7.14 kW DC PV SYSTEM  
FORNAH SOLAR PROJECT  
183 Tun Tavern Dr, Cameron, NC 28326  
LINE DIAGRAM

E-01

7.14 kW DC PV SYSTEM  
FORNAH SOLAR PROJECT  
183 Tun Tavern Dr, Cameron, NC 28326

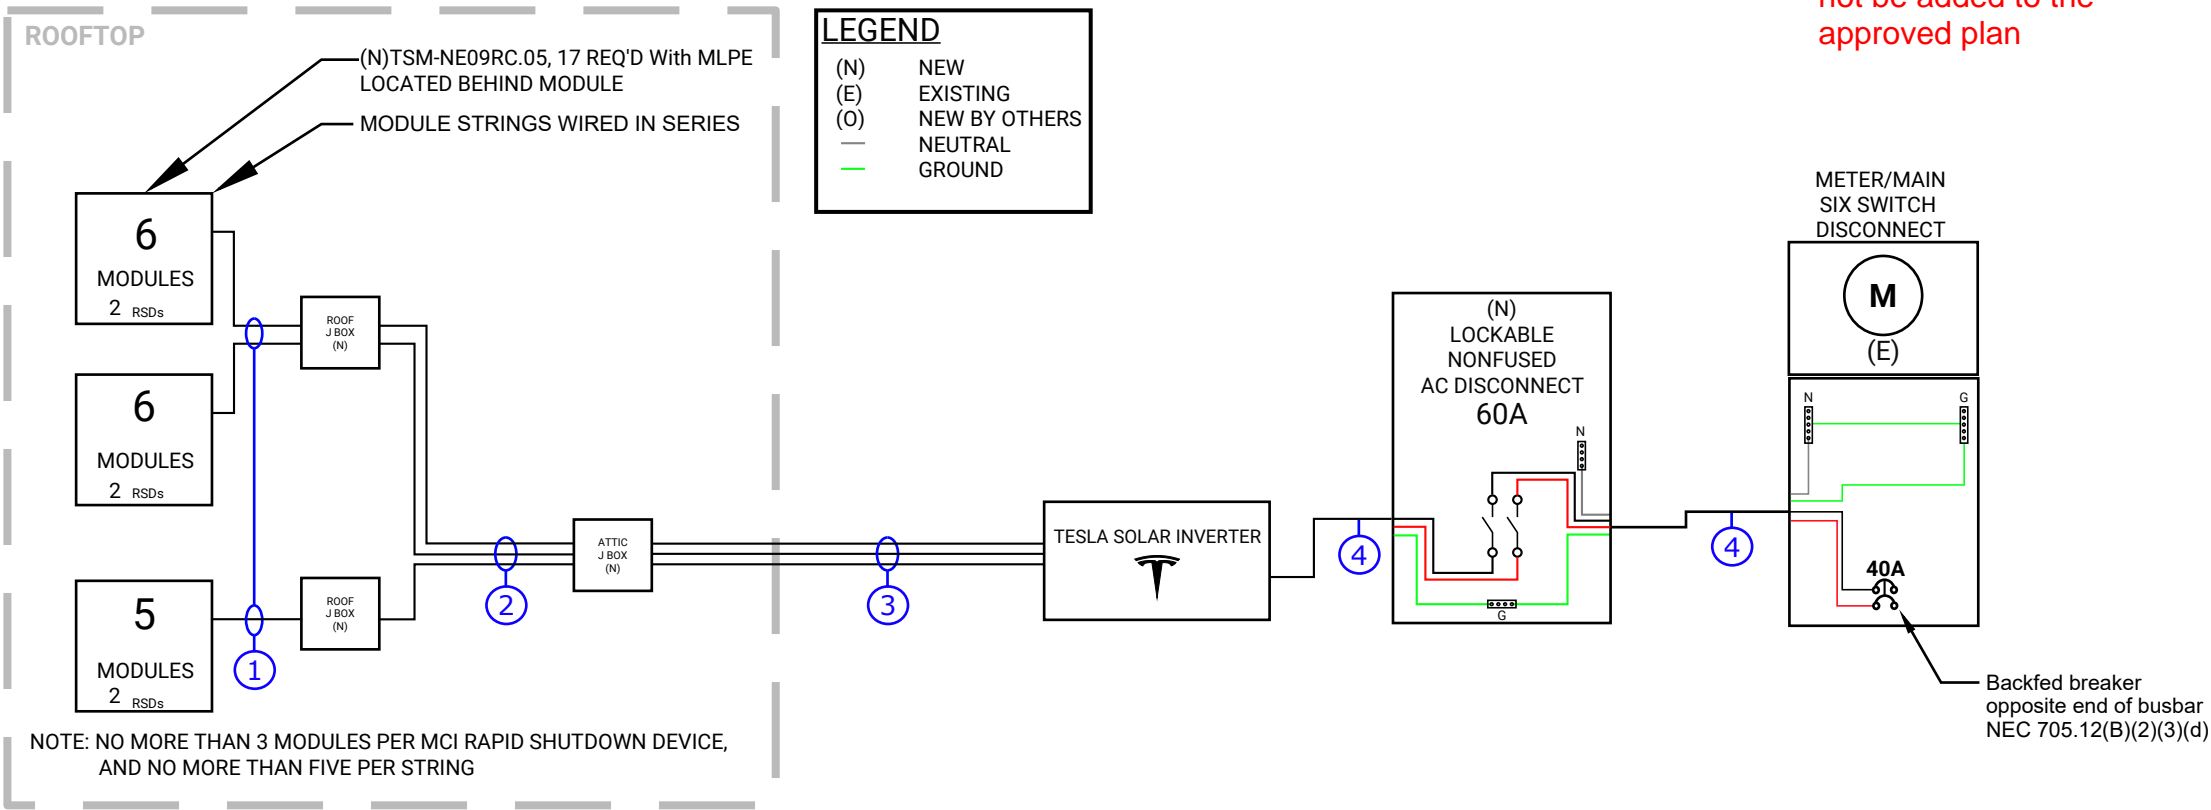
Additional info provided is a locked file, and could not be added to the approved plan
